# PORT OF TACOMA

## SITE FACILITIES FOR TACOMA TERMINALS INC.

### CONTAINER TERMINAL CONTRACT NO. 560

DRAWN RHT DATE 5-29-84	<b>PORT OF TACOMA</b> TACOMA TERMINALS, INC. COVER SHEET	SCALE NONE
CHECKED LTP DATE 5-30-84		DRAWING NO. EP-3880-23-G001
CHECKED P DATE 5-30-84		SHEET 1 OF 88
FIELD BOOK (S)		
APPROVED John J. Terpstra 5/31/84 DATE	PROJECT MANAGER Robert L. MacLeod 5/21/84 DATE

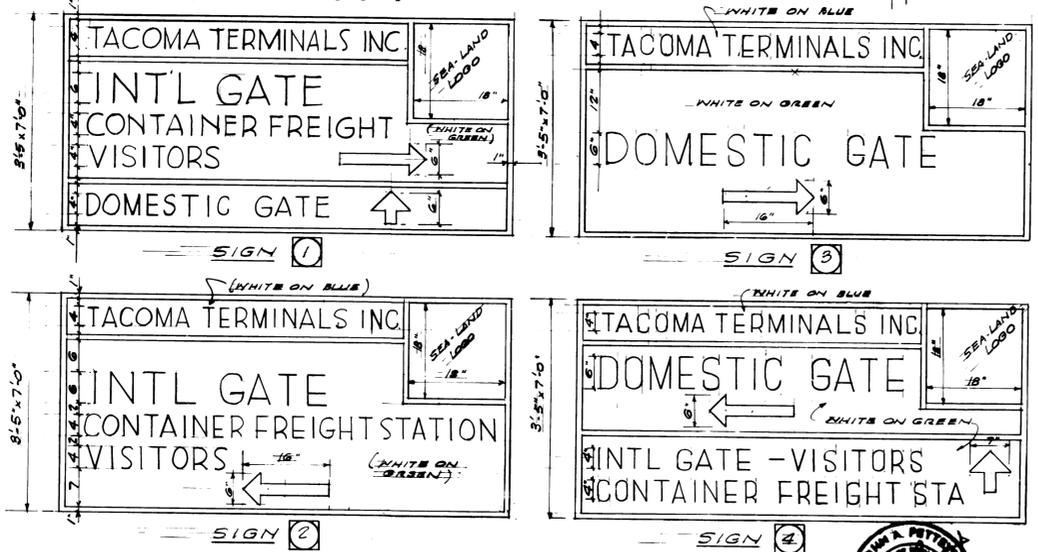
SEE SECTION 02840 FOR SPECIFICATIONS  
SIGN 2 SHALL BE 1/8" REFLECTORIZED SHEET ALUMINUM.  
SIGN PER REVISION DNG #2 DATED 4-11-85  
SEE SHEET 3 FOR SIGNS ③ ④

FIELD BOOK (S)		SCALE	AS NOTED
APPROVED	<i>[Signature]</i>	DATE	5/31/84
PROJECT MANAGER	<i>[Signature]</i>	DATE	5/31/84
CHIEF ENGINEER	<i>[Signature]</i>	DATE	
DRAWING NO.	EP-3880-23-C106	SHEET	8 OF 88

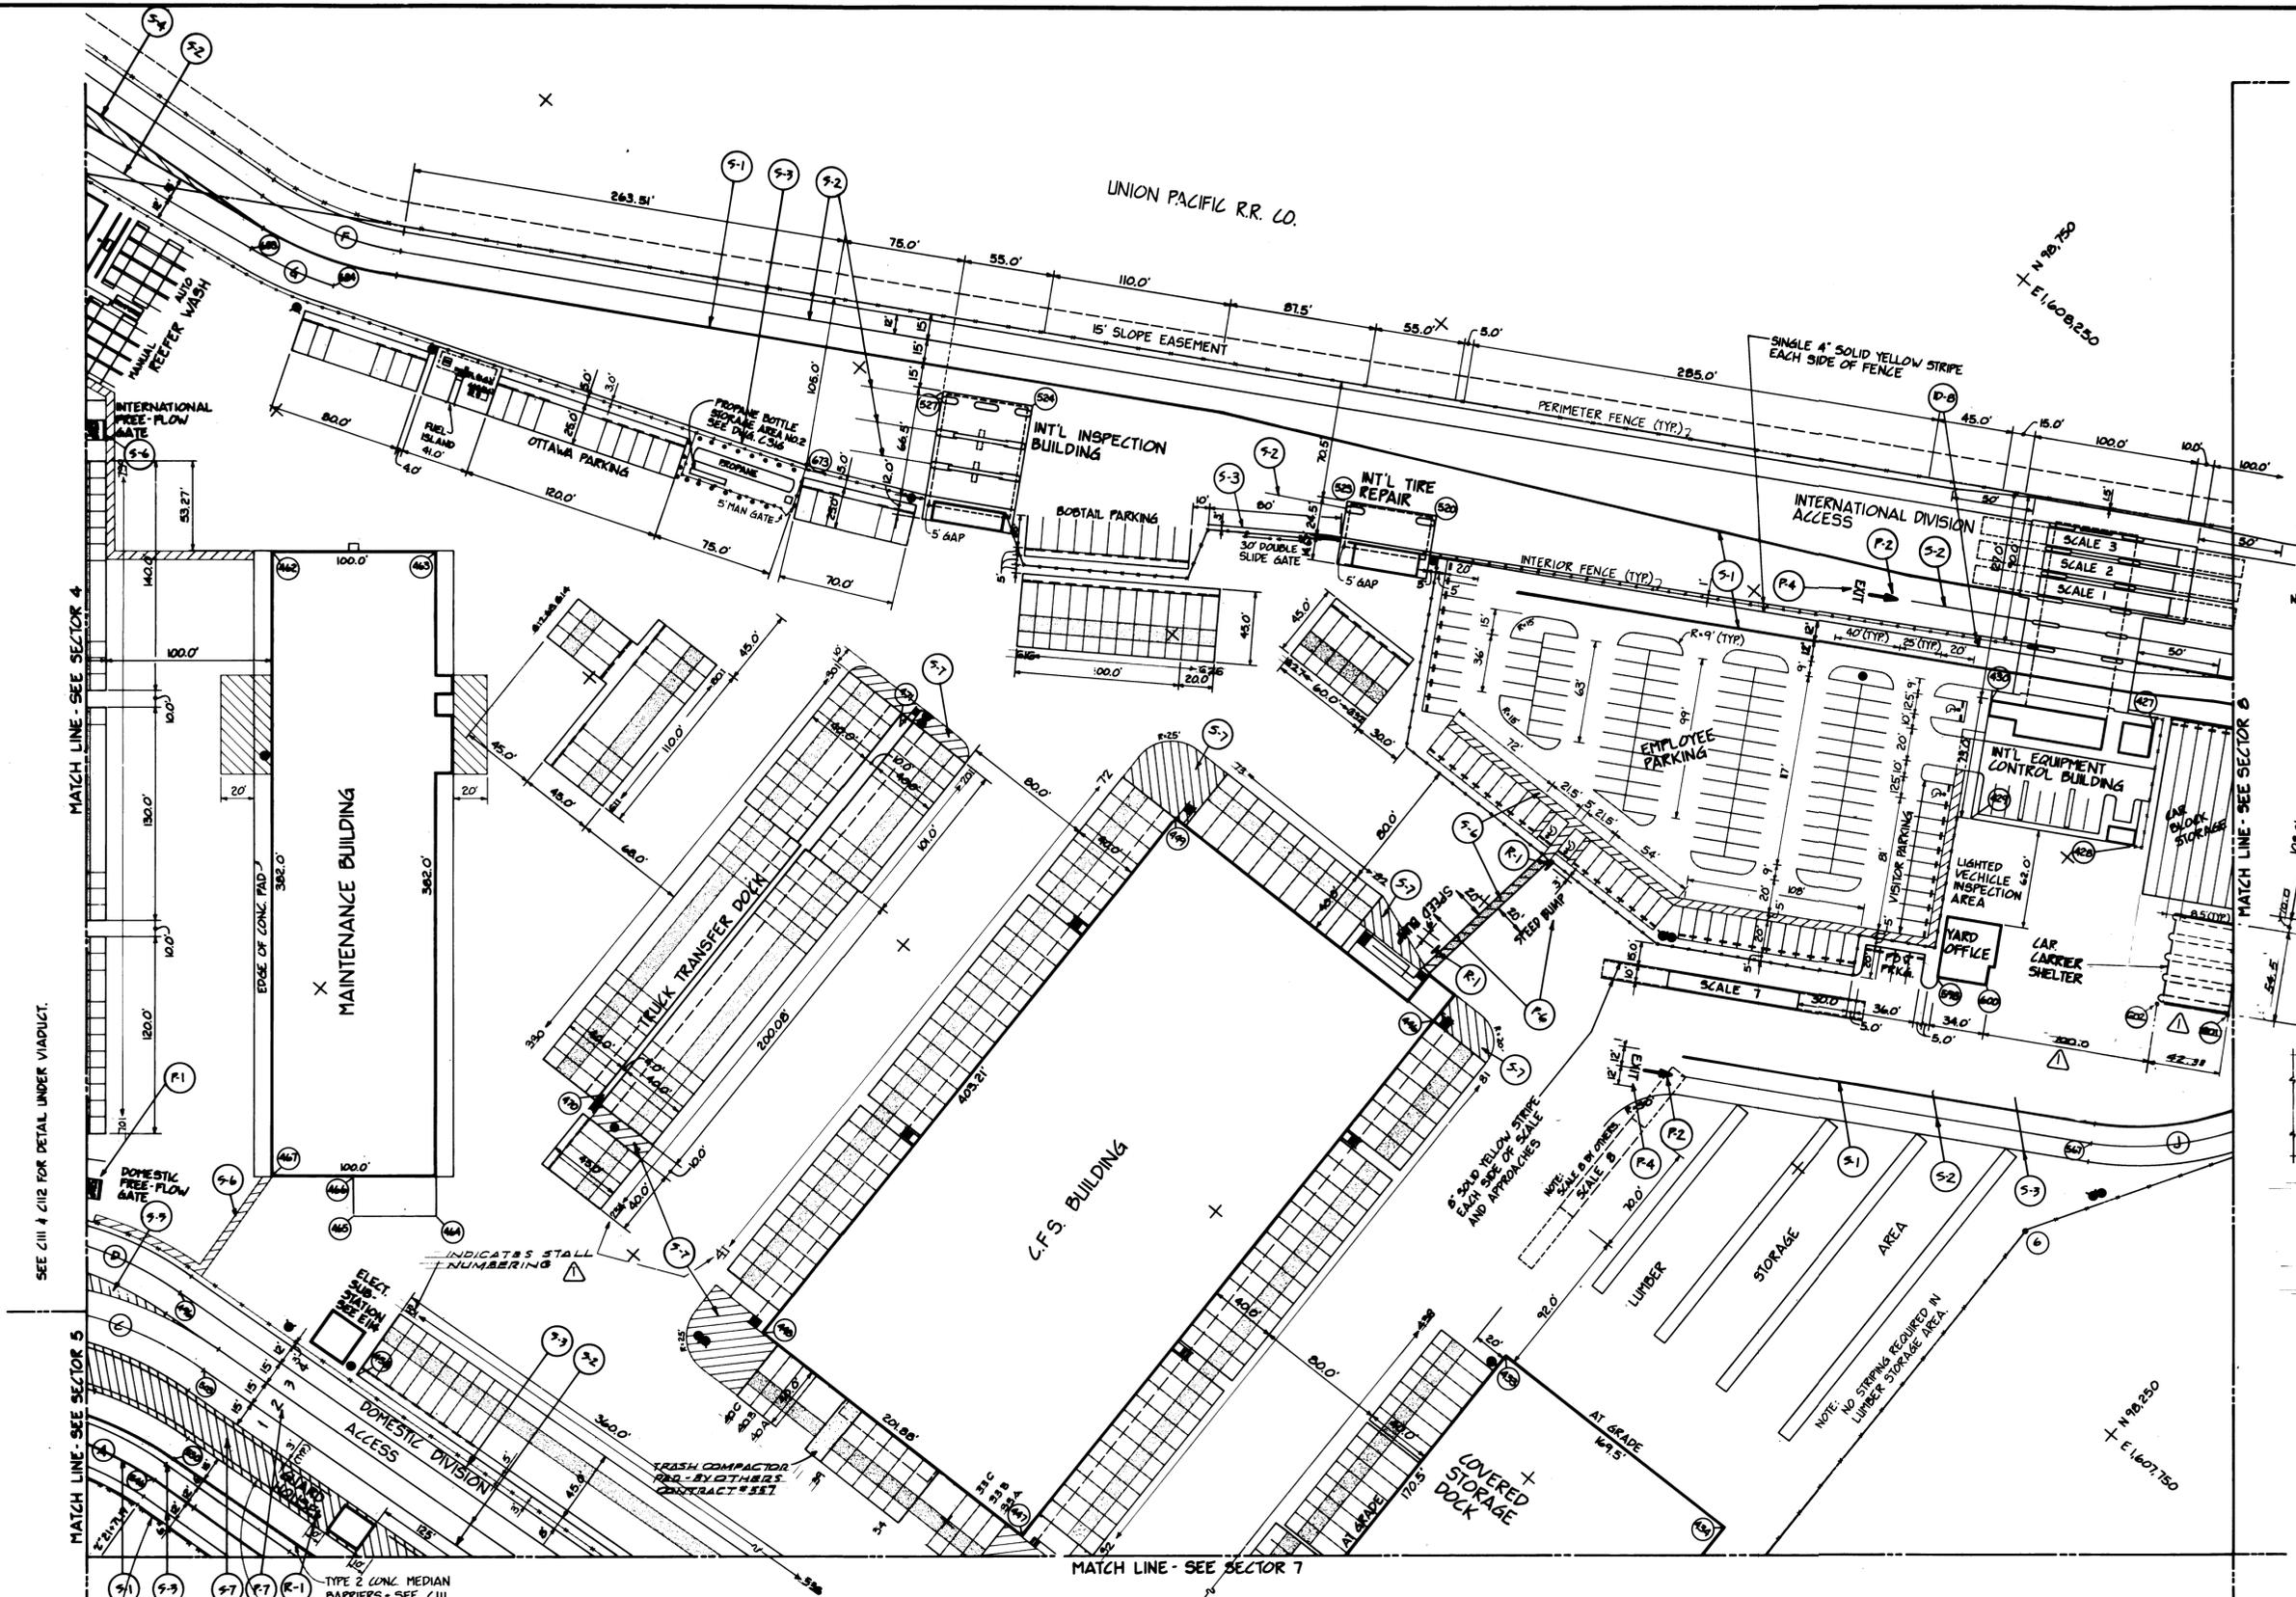
*D.D. 10' x 200' As Shown  
see 772 letter d'ta 9-19-85*

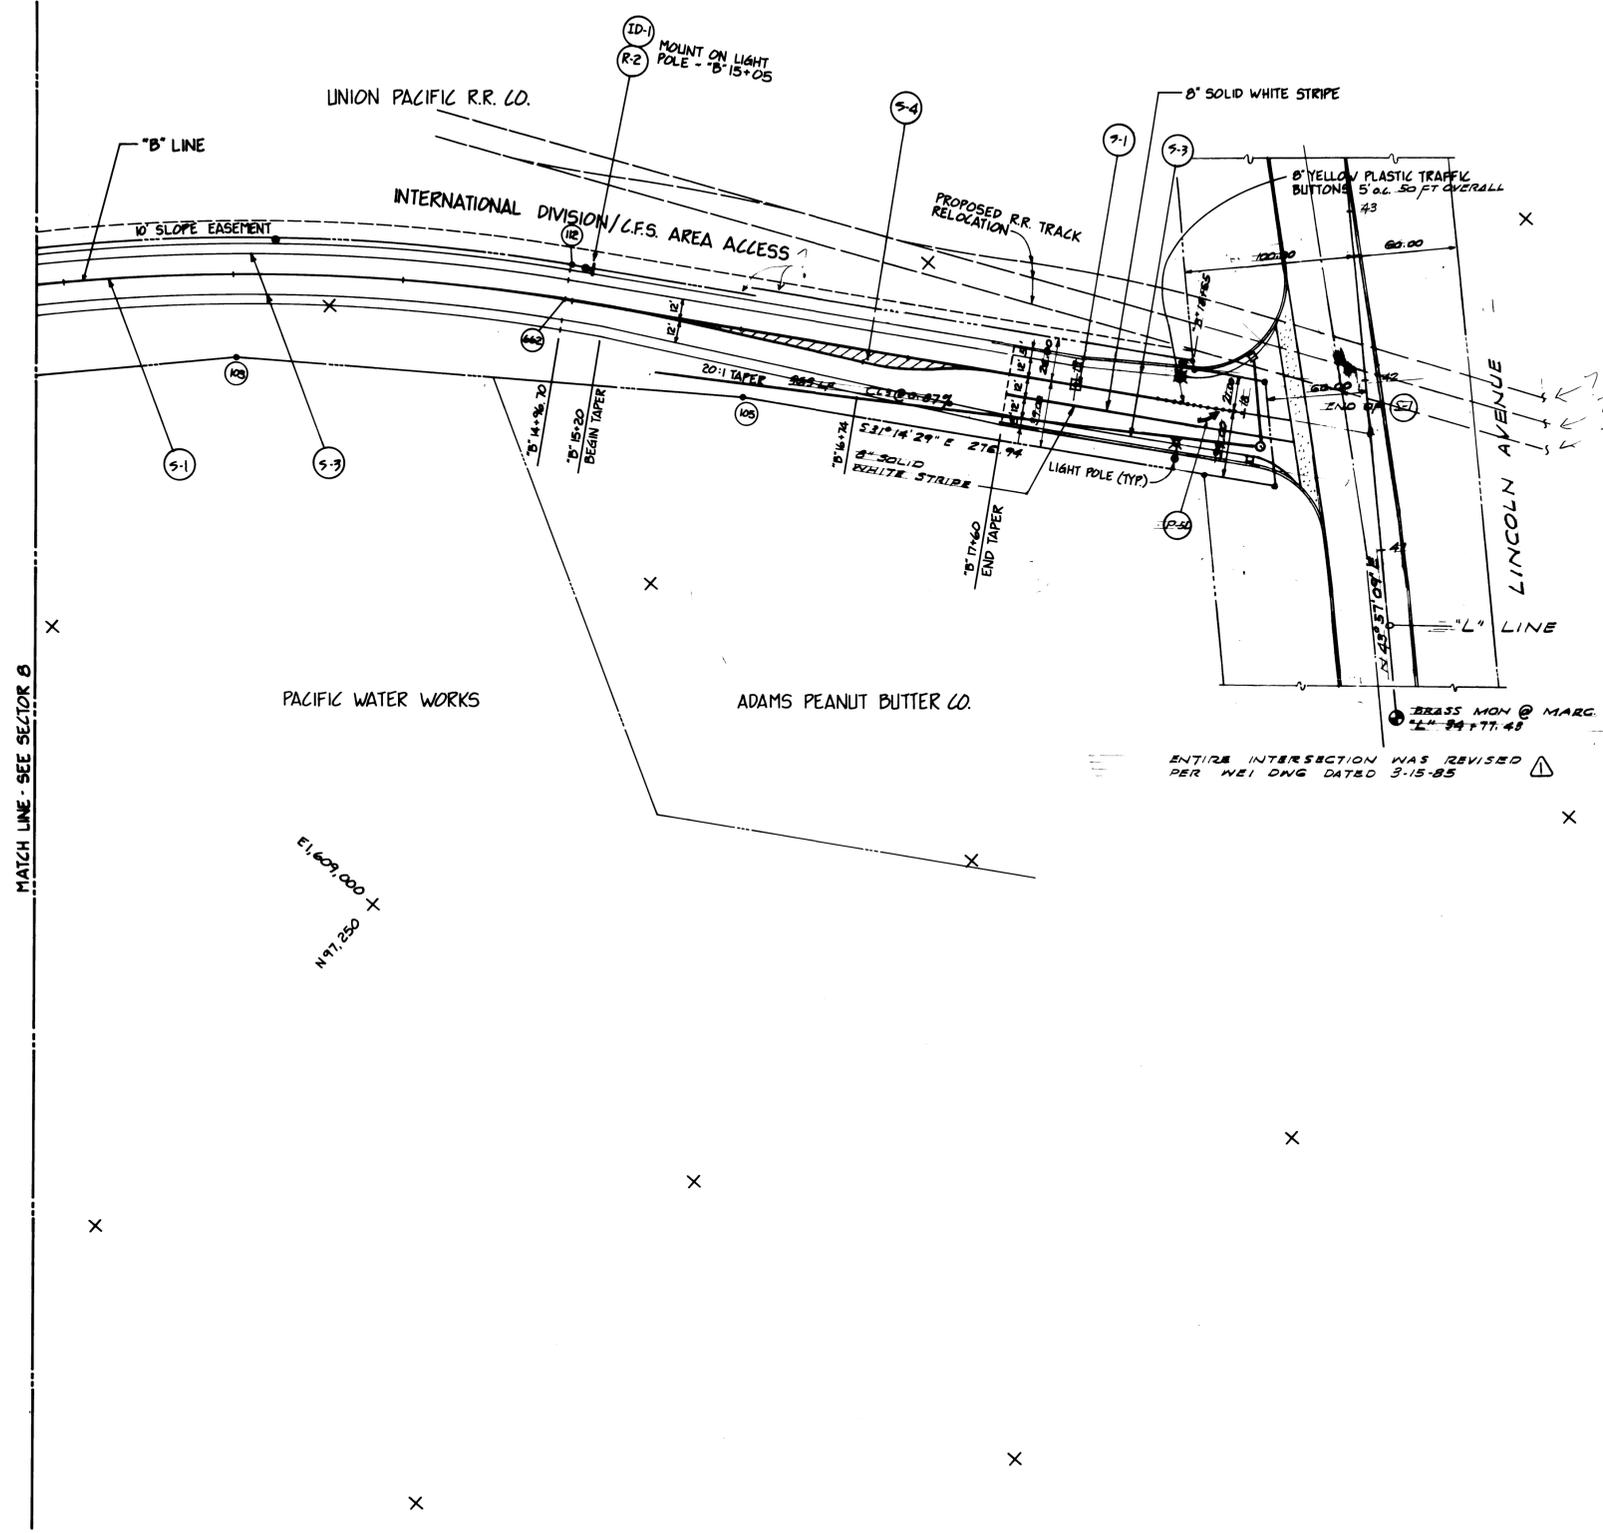
ENTIRE INTERSECTION WAS REVISED  
PER MEETING DATED 3-15-85

1. EXTENT OF CURB ?
2. R/R - PACIFIC RAILROAD ?
3. LOCATION N.E. P.L. ?

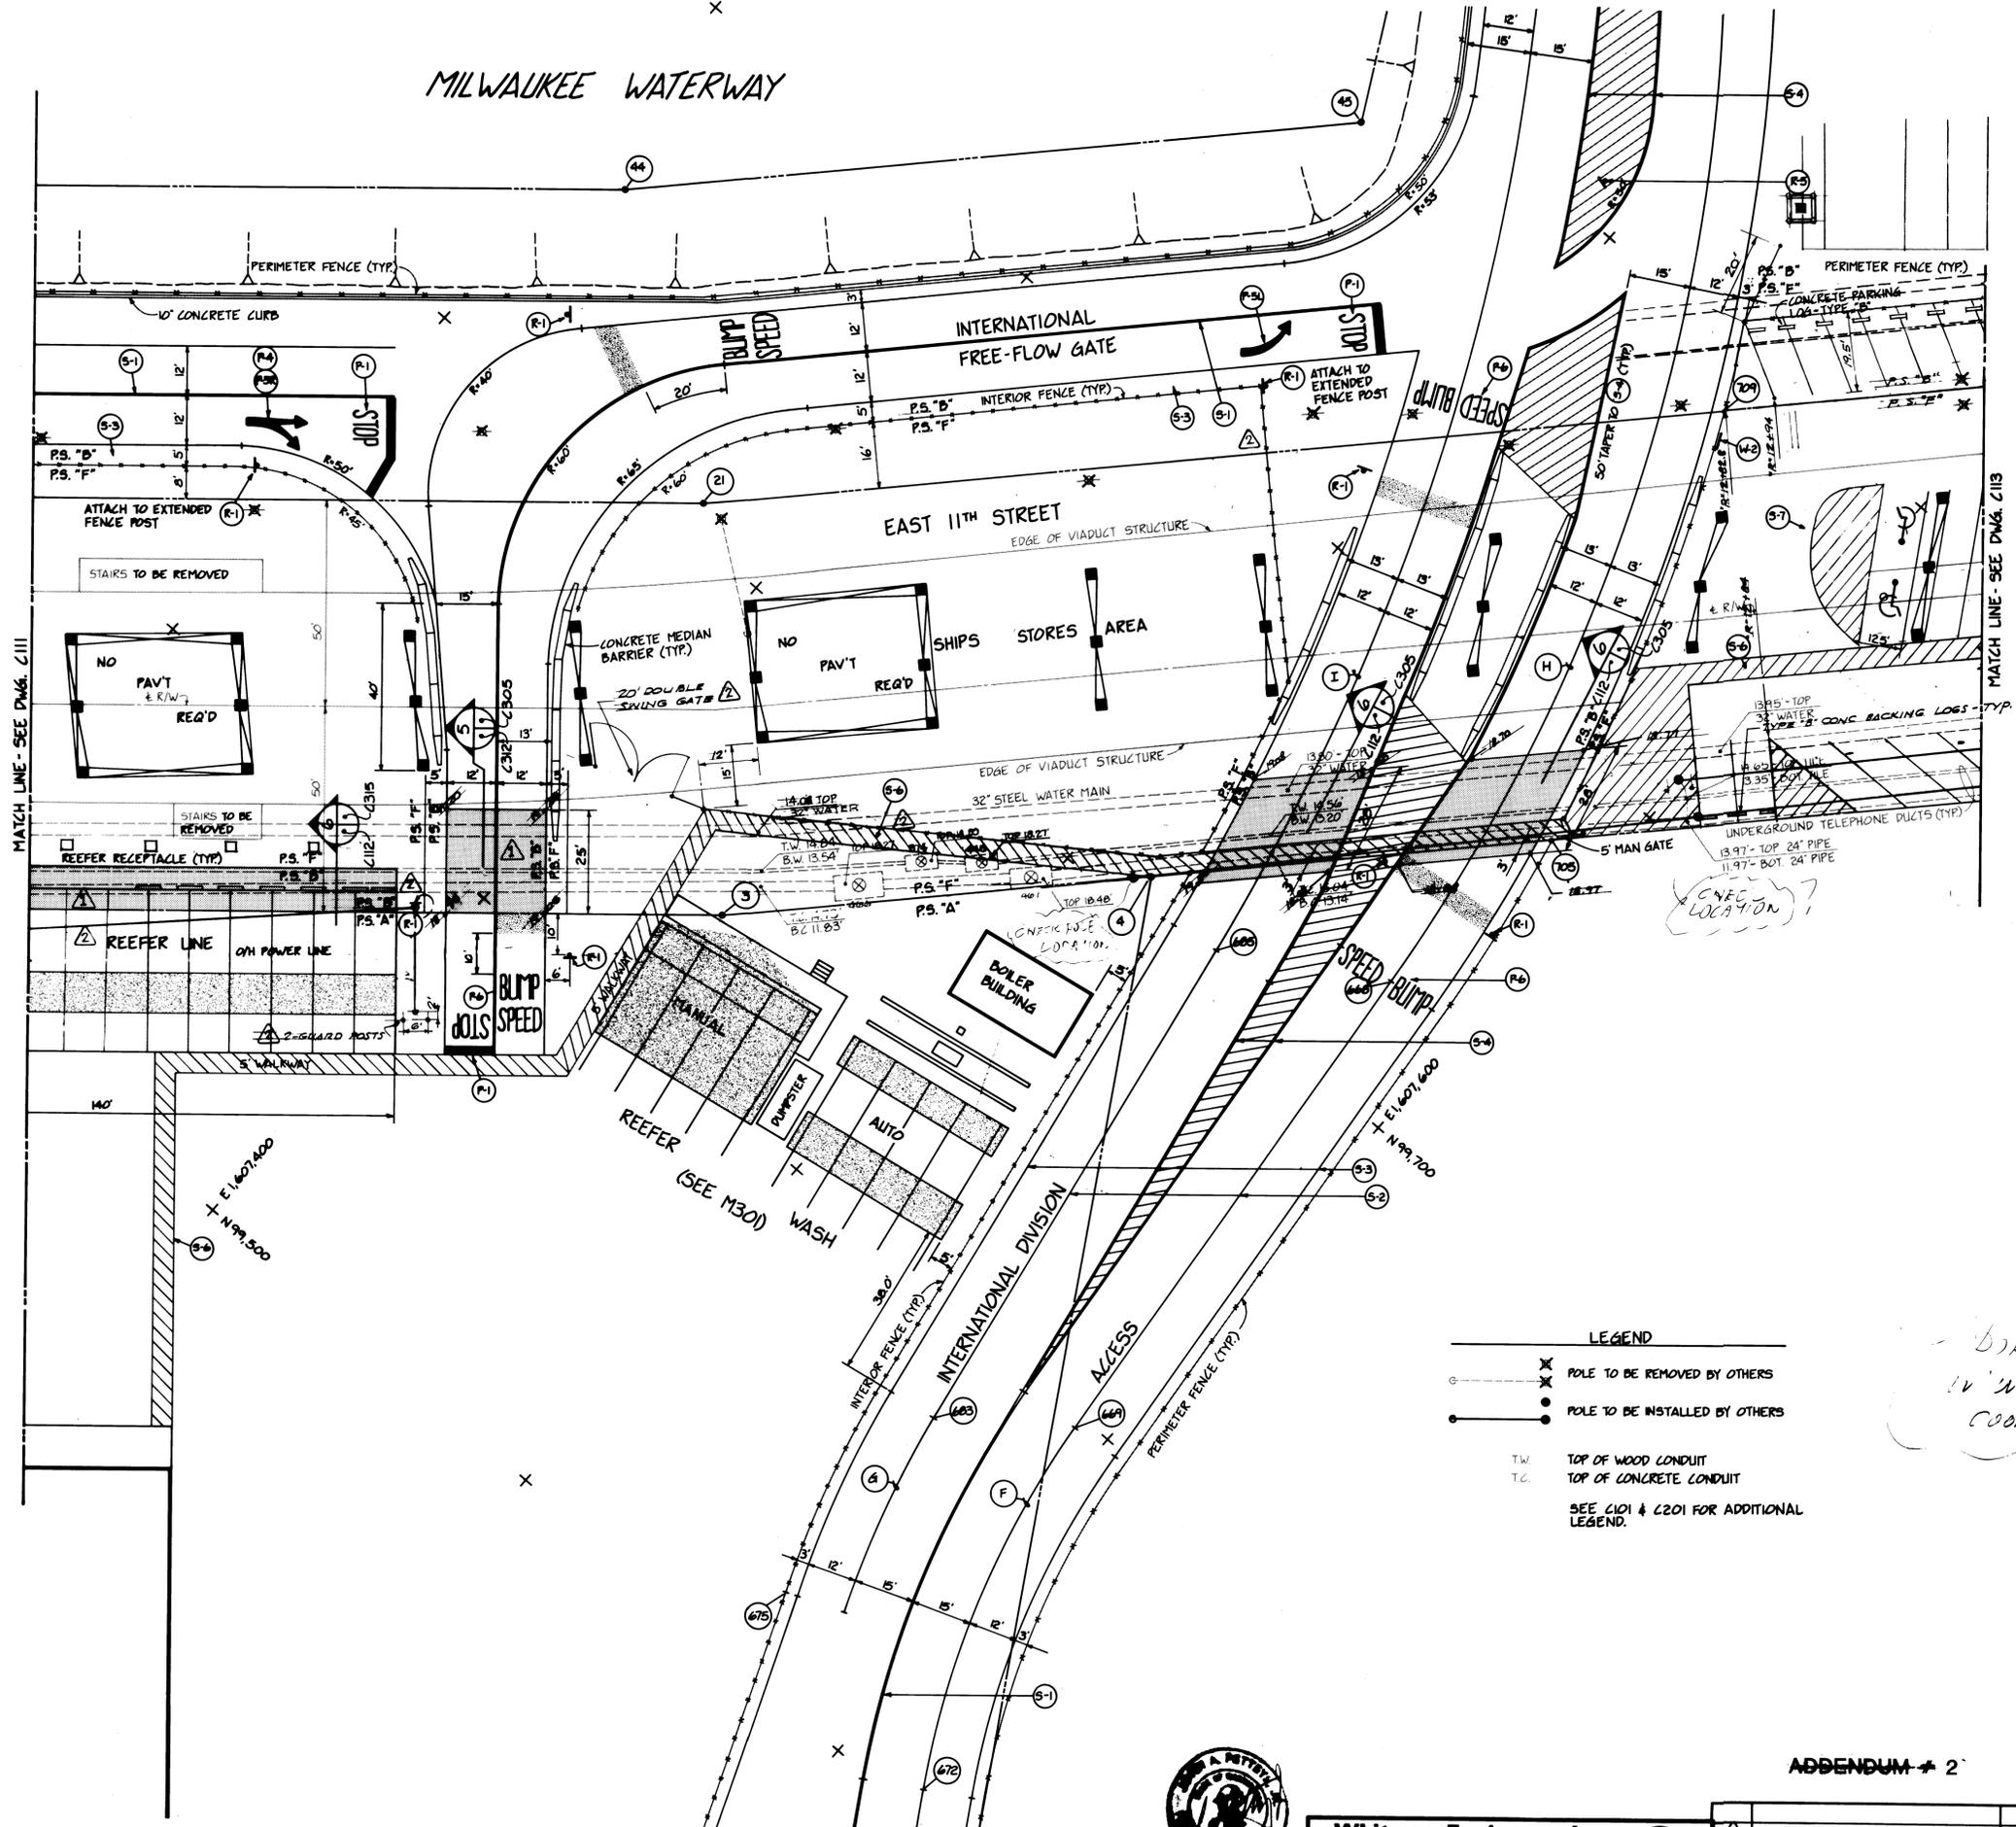
*DOES NOT APPEAR  
IN THE LWB FOR FENCE  
COORDINATES STA 12-17-94  
CHECK LOCATION OF  
LARGE POLES?*
